**TOWN OF BAY HARBOR ISLANDS  
MORRIS N. BROAD COMMUNITY CENTER  
1175 95TH STREET  
BAY HARBOR ISLANDS, FL 33154**

**MEETING OF THE DESIGN REVIEW BOARD**

**March 4, 2025  
7:00 PM**

**Subject:** Site Development Plan Application  
Bay Harbor Luxury Townhomes - 5 DU Complex  
9761 West Bay Harbor Drive  
Bay Harbor Islands Acct. No. SPR2024-000021  
MMPA Acct. No. 01-0702-1196

**SITE PLAN**  
 SCALE: 1/8"=1'-0"

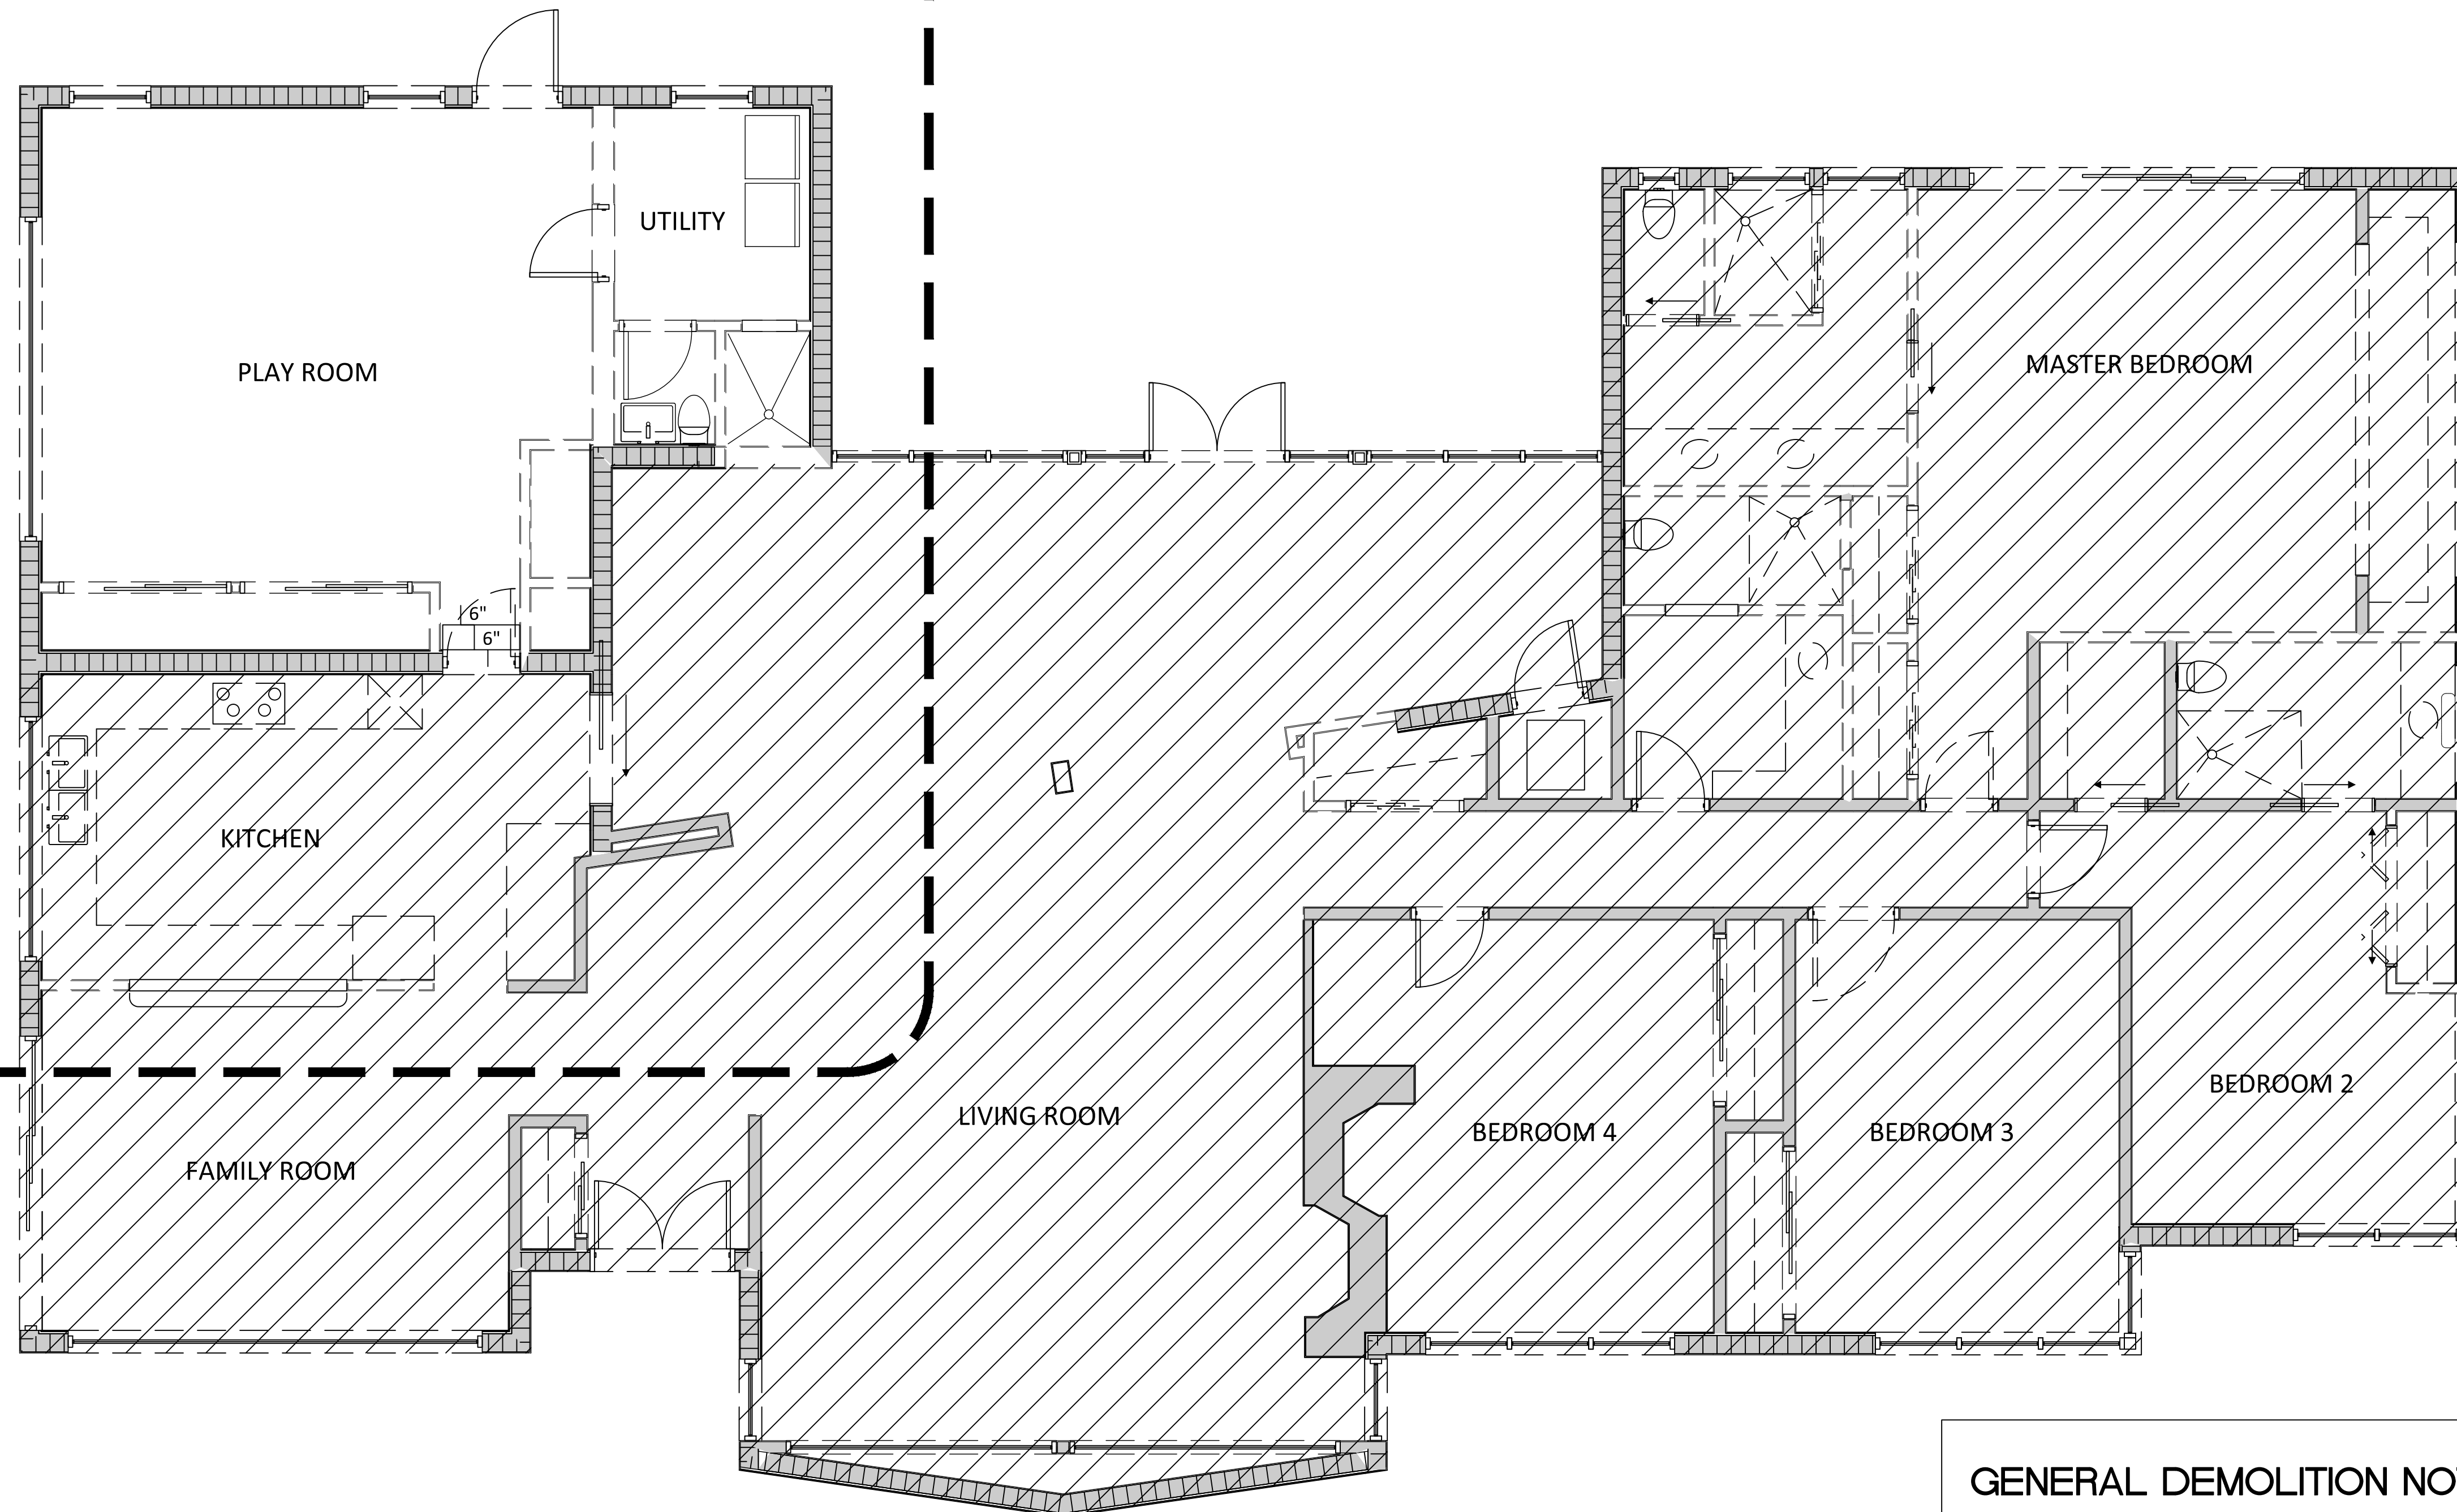
This property is an oddly shaped corner lot. The BHI developer's Deed Restrictions and current Zoning Code allow for the modification of setbacks based on each situation due to unique lot shapes or circumstances. The house / site design predates the current Zoning Code as to "yard" definitions and setbacks. It appears when the home was built in 1959 the south property line was considered a "side" (10' min. setback) and the east property line was considered the "rear" (15' min. setback) as the house faces westerly. By current Zoning Code definition, the south property line is the "rear" of the lot. Both the west and north lot lines adjoin roadways which require a min. 25' "front" setback. The survey indicates the existing house meets the 25' setback to 97<sup>th</sup> Street but some portions of the house do not meet that requirement along West Broadview Drive due to the unusual house architectural design (as little as 15'-5" per the survey) and lot shape. This site is considered legal nonconforming as to those existing setbacks. No portion of the 2<sup>nd</sup> story addition or interior house renovations will affect the existing house footprint. In addition, a swimming pool / deck is built in the "side street" setback area facing 97<sup>th</sup> Street which is allowed (fenced / screened with landscaping). The existing home has some prominent roof eave yard encroachments that will remain (do not meet current 2' max. yard encroachment). Finally, the current Code requires a minimum of 35% landscaped open space for one-story homes but a minimum of 40% for 2-story homes. From the plan information provided the site currently has about 37% of the site as landscaped open space (OK for existing 1-story home). While the new 2<sup>nd</sup> story addition would technically require more ground level open space, due to the existing site design and features it would be difficult to meet the 40% requirement (remove hardscape). Therefore, we feel the Town should grandfather the existing setback / open space situation.

WEST ELEVATION

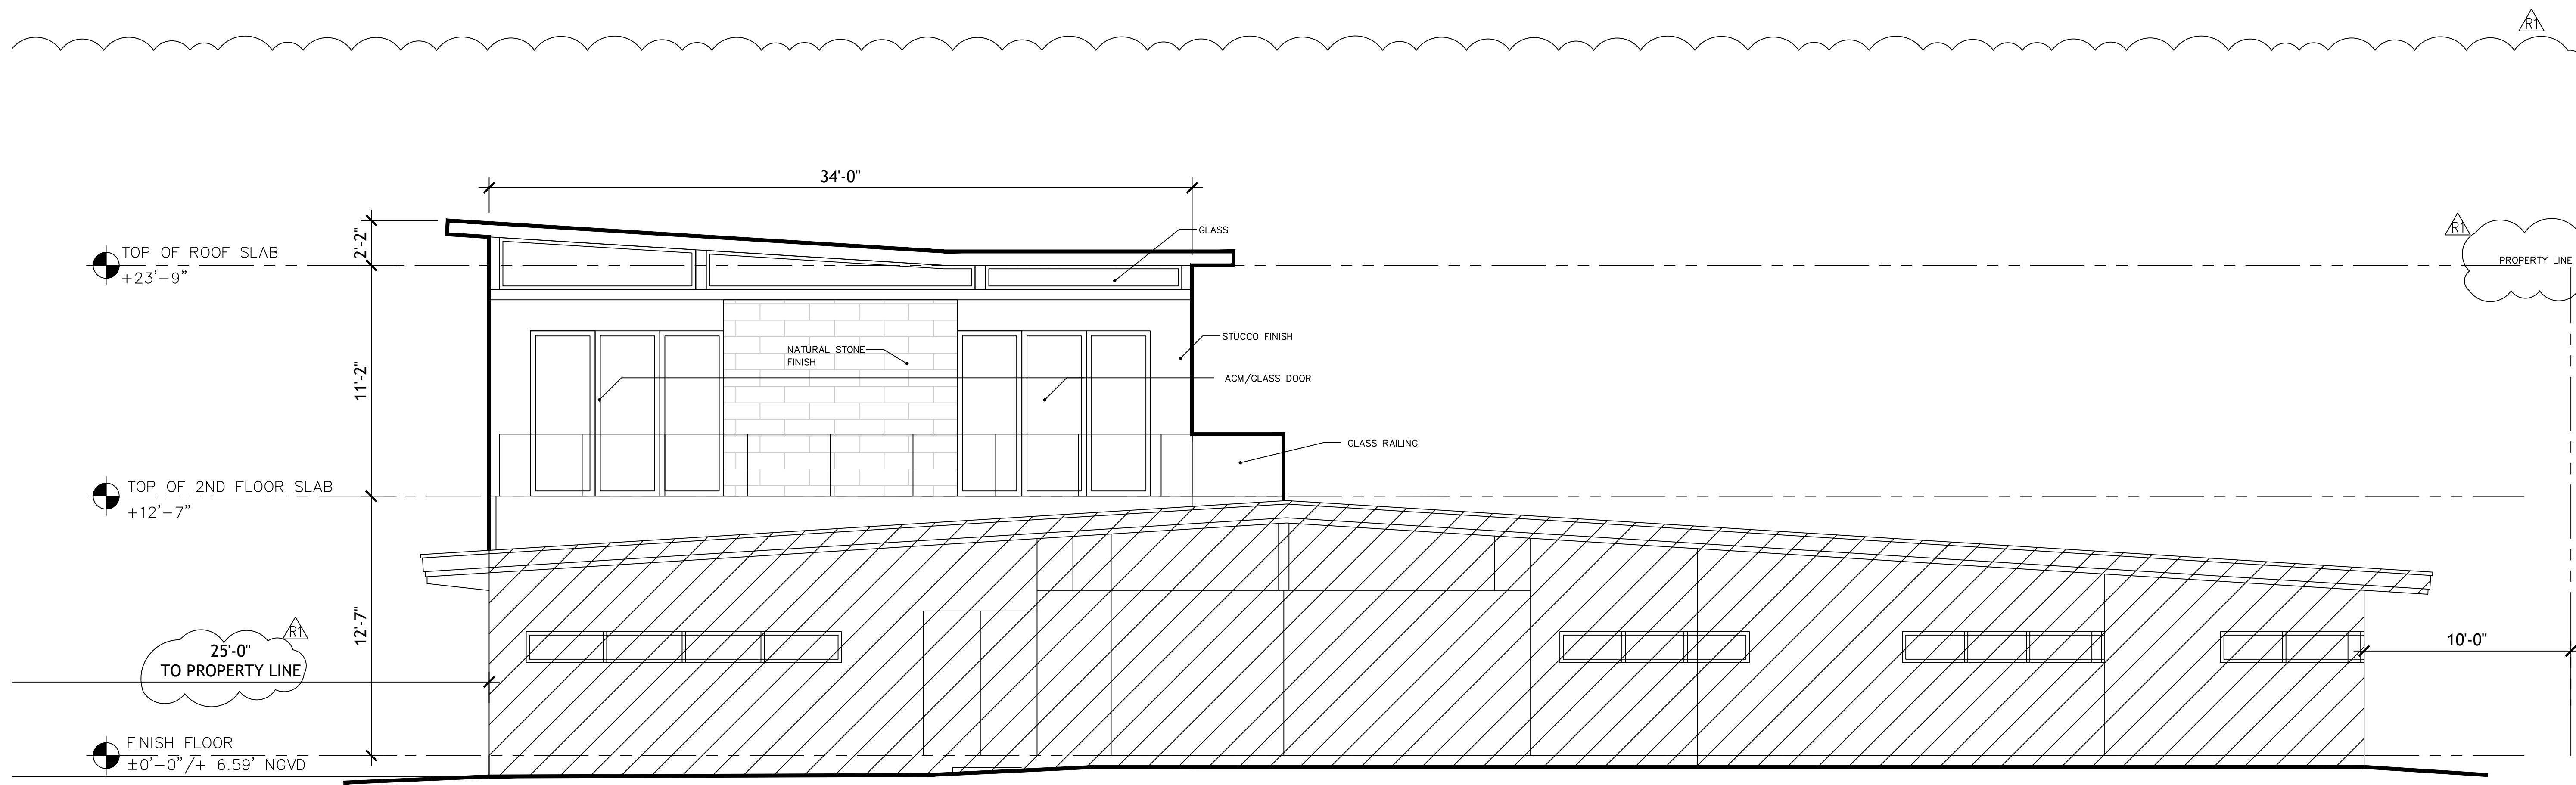
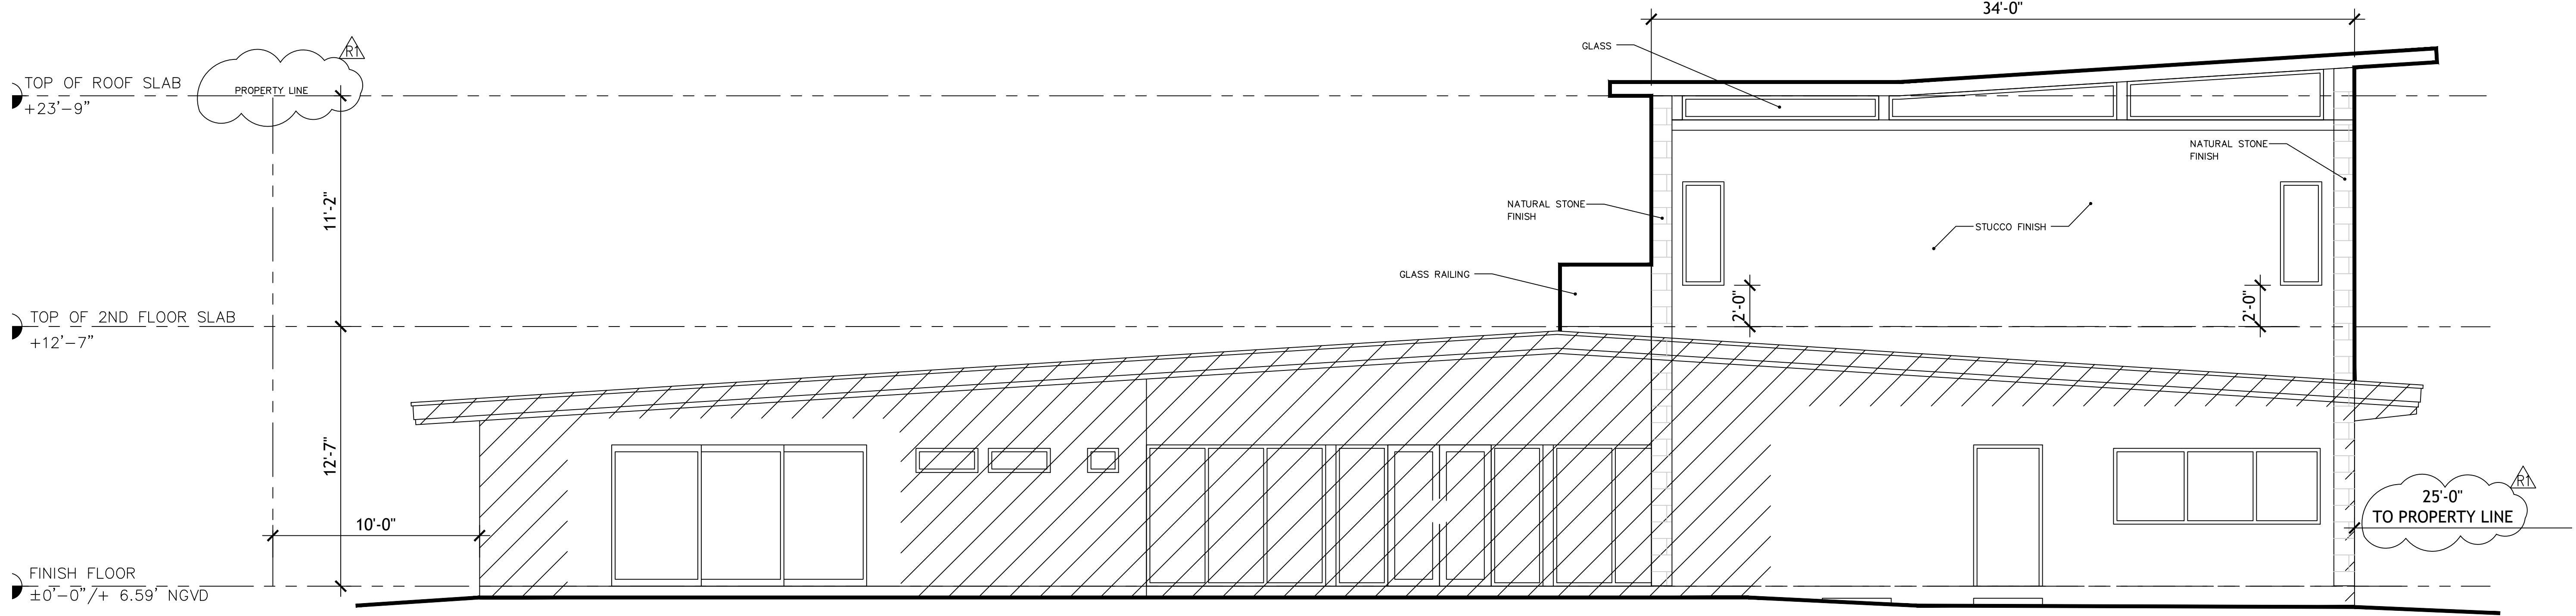
This 1950s Ranch style home has a unique footprint and architecture with some very wide roof eave overhangs, especially facing West Broadview Drive. These are planned to stay. For the new 2<sup>nd</sup> story addition, the architect has attempted to incorporate features & materials to match the existing ground level house. The house will have a white stucco exterior finish. The existing landscaping appears to meet the Miami-Dade County Landscape Code and Town Supplemental Landscape Code requirements. Further landscaping improvements are always welcome.
